UGL0143908/CU-754

CE Reference No. Gladwin/Beaverton/1023346492/Hall

Proposed distribution work in area of METC 120 kV Transmission Bard Road-Warren Lane 6L

Subject: Proposed Distribution Work in Area of METC 138kV Transmission Line – Bard Road Warren Line, 6L

Transmission line Pole No. 9382

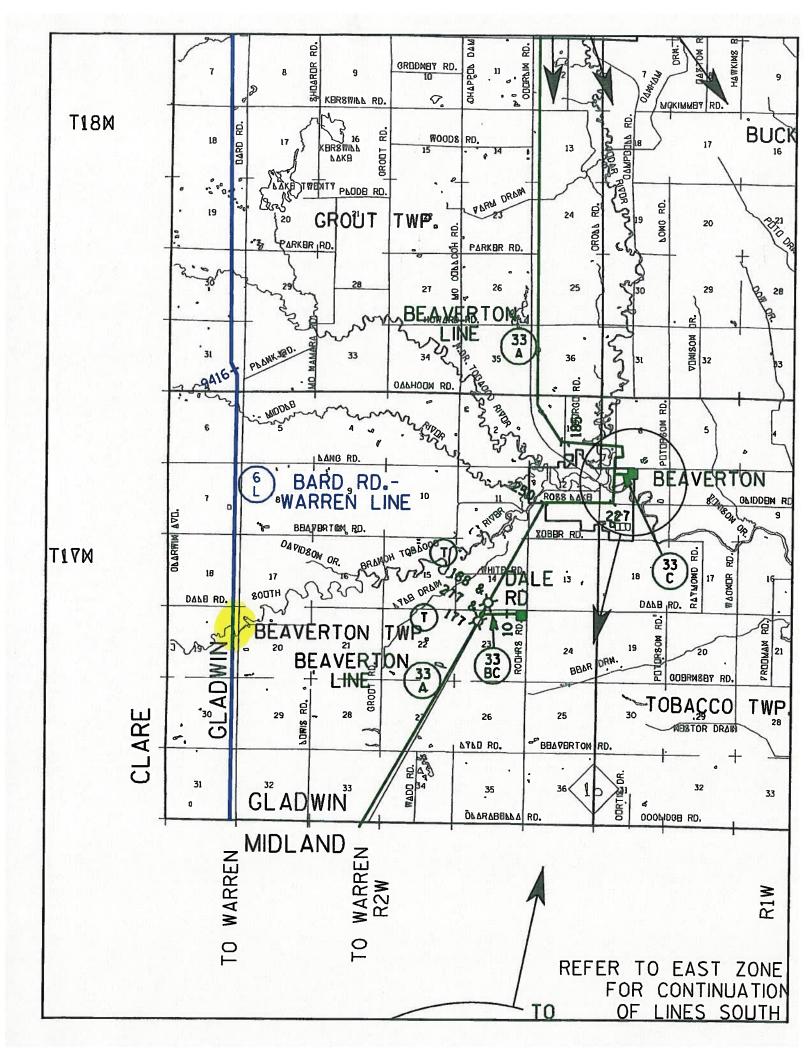
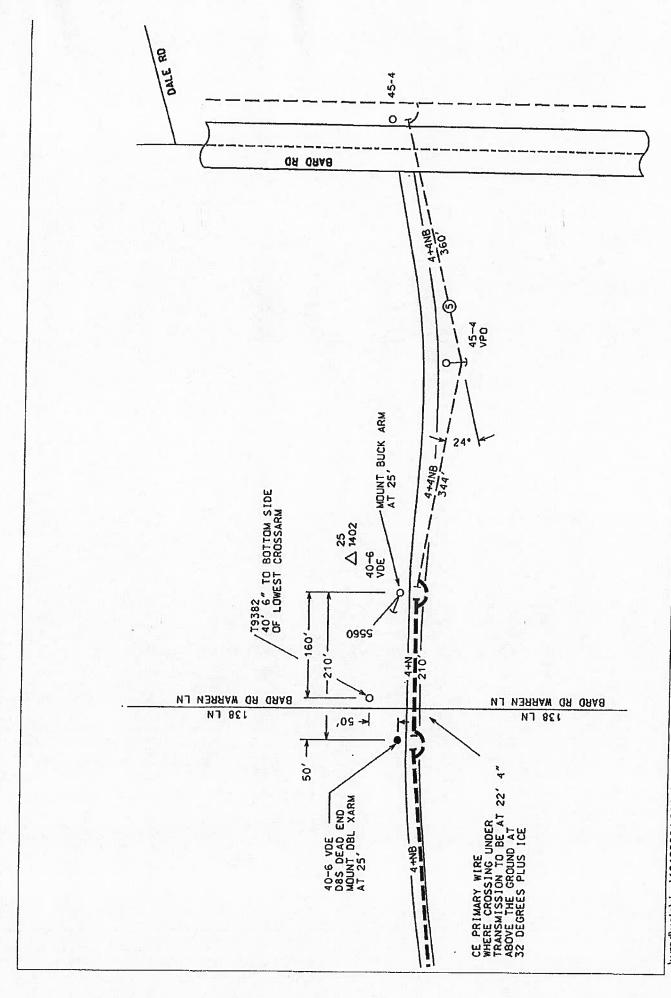
- 1. CE LVD conductors not to exceed 25' from the ground at conductor crossing at winter ambient temperature of 50° F
- 2. CE LVD pole be placed at least 20' west from the existing ITC pole 006L9382
